ADDENDUM

Notice Inviting Tender No.: KoPT/KDS/Mech/SP/ADV/519 dated 12.03.2019

Tender for “Thorough Overhauling and Round-the-clock Maintenance Support for 5 years of the Swing Bridge of Kolkata Port Trust”

(Pursuant to the queries raised by the intending bidder in the pre-bid meeting held on 29.03.2019, KoPT’s clarifications /decisions as have been finalised and frozen thereon are given below:-)

Swing Bridge(main) Cylinder
Drawing No.W – 3474

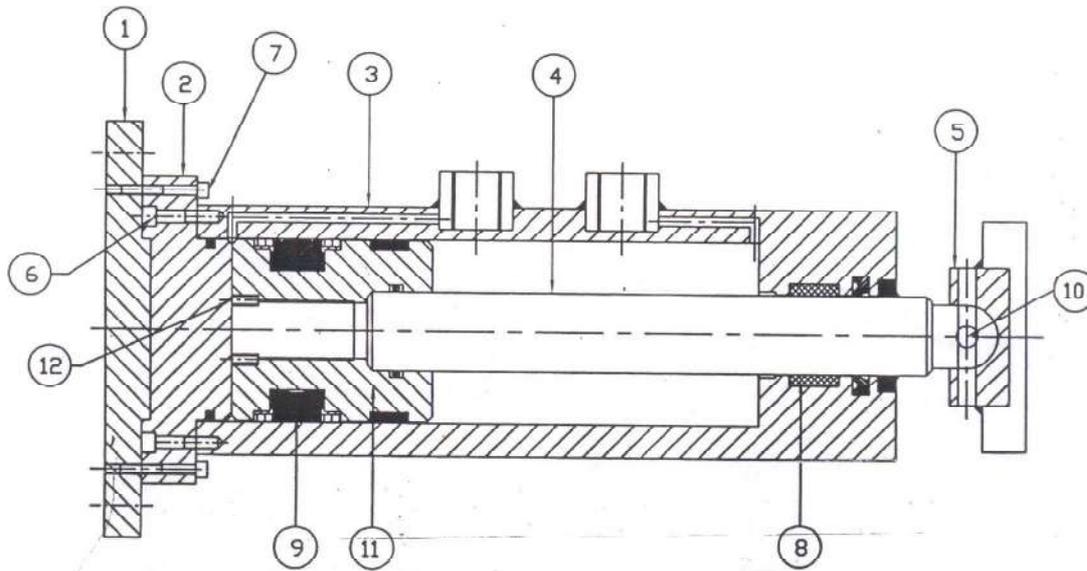
| ii | Removal of 1 damaged cross head assembly from RAM, free issue from KoPT- Please give the drawing and weight of the same for us to look into how to remove and fit new one. Note - Please allow us to take out photographs / videos wherever are people require to take out the same for our records. | Relevant drawing as available with the Department uploaded with this Addendum as Annexure-I |
